Version 3

## A/C Does Not Blow Cold Air and Condenser Leaks at Receiver Dryer Cap

Supersedes 18-080, dated August 25, 2018, to revise the information highlighted in yellow

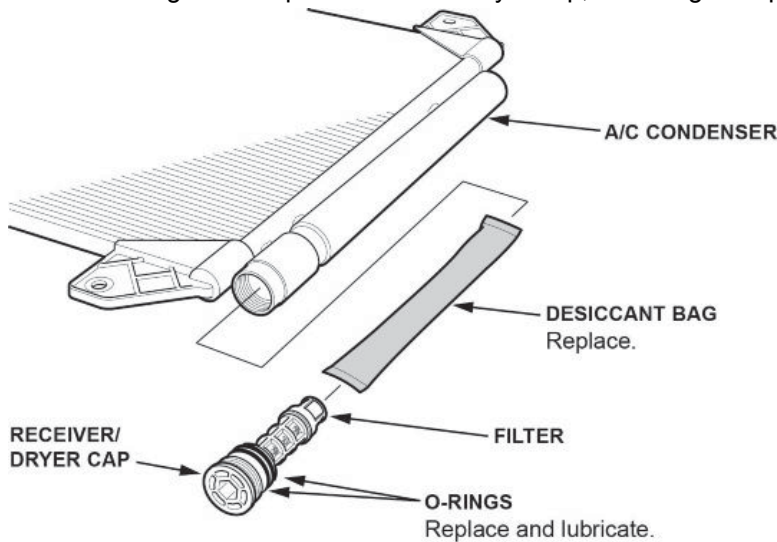
1. Recover the A/C refrigerant from the system. Refer to the service information.
2. Remove the A/C condenser from the vehicle. Refer to the service information.
3. Thoroughly clean the stain from the affected area on the condenser.

4. Remove the sub-assembly (cap, filter, and desiccant bag) from the condenser.

- Install the new desiccant bag as quickly as possible to prevent the system from absorbing moisture from the air.
- You will need to add **10 ml** of refrigerant oil (P/N 38899-RLV-A01) with the replacement of the desiccant bag.
- Do not over tighten the plastic receiver/dryer cap; it could get stripped.

5. Wipe the interior threads and sealing area of the receiver/dryer barrel with a lint-free cloth to remove all debris.
6. Apply a thin layer of refrigerant oil to the O-rings. Then install the new filter sub-assembly, and torque the cap to **12 N·m (9 lb-ft)**.
7. Install the A/C condenser. Refer to the service information.
8. Evacuate and recharge the A/C system. Refer to the service information.
9. Make sure the A/C system is operating properly.
10. **With Honda Sensing: Do the millimeter wave radar aiming procedure. Refer to service information.**
